**Informal document N° 8**  
*(32<sup>nd</sup> GRSP, 10-13 December 2002  
agenda item B.2)*

## **ISOFIX – AMENDMENTS TO REGULATION 14**

### ***OICA contribution to document TRANS/WP29/GRSP/2001/14/Rev.2***

**Figure 13 — Symbol Used to Identify the Location of a Top Tether Anchorage that is under a Cover**

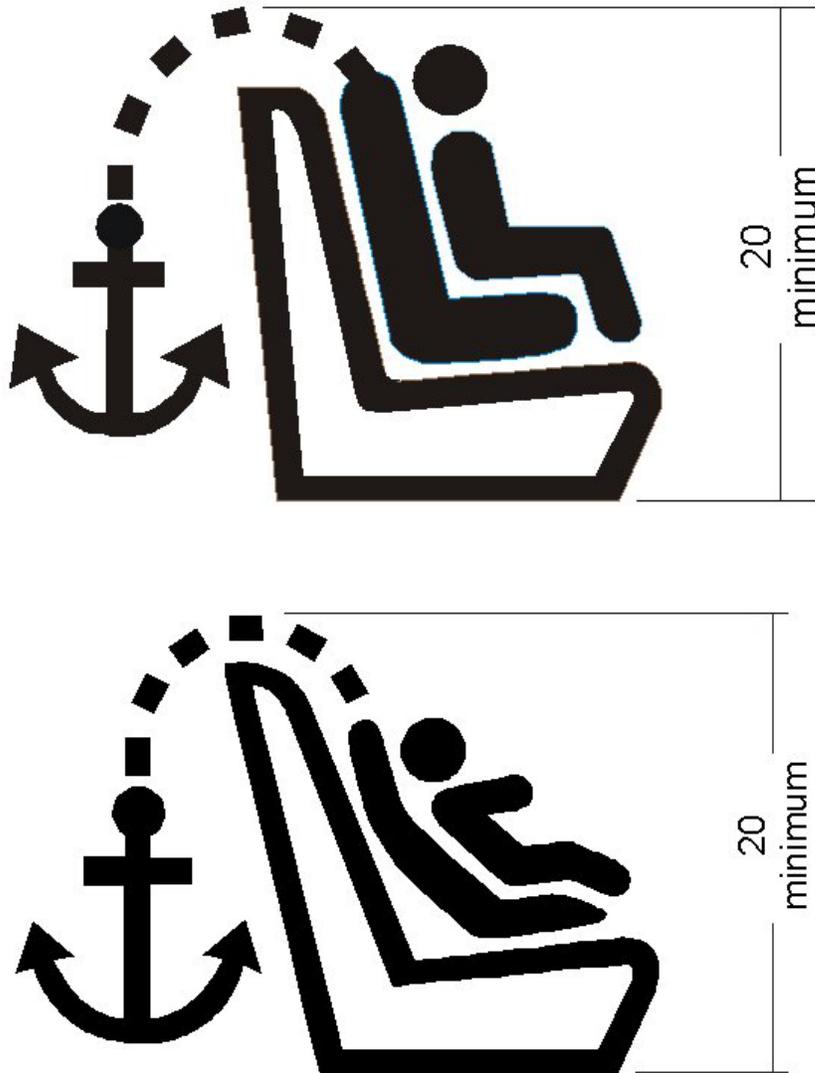
"5.2.4.4. The ISOFIX top tether anchorage shall have ... Figure 3. Clearance shall ... to it. For each ISOFIX top tether anchorage under a cover, the cover shall be identified by for example one of the symbols or the mirror image of one of the symbols set out in Figure 13 of Annex 9; the cover shall be removable without the use of tools."

**Add, in Annex 9, a new Figure 13, as follows:**

At the last GRSP ad hoc meeting, OICA was requested to prepare a proposal on the marking/identification of the top tether anchorage on the vehicle. The above proposal (para. 5.2.4.4 and Figure 12) was taken from the Canadian Motor Vehicle Safety Regulation 210.1.
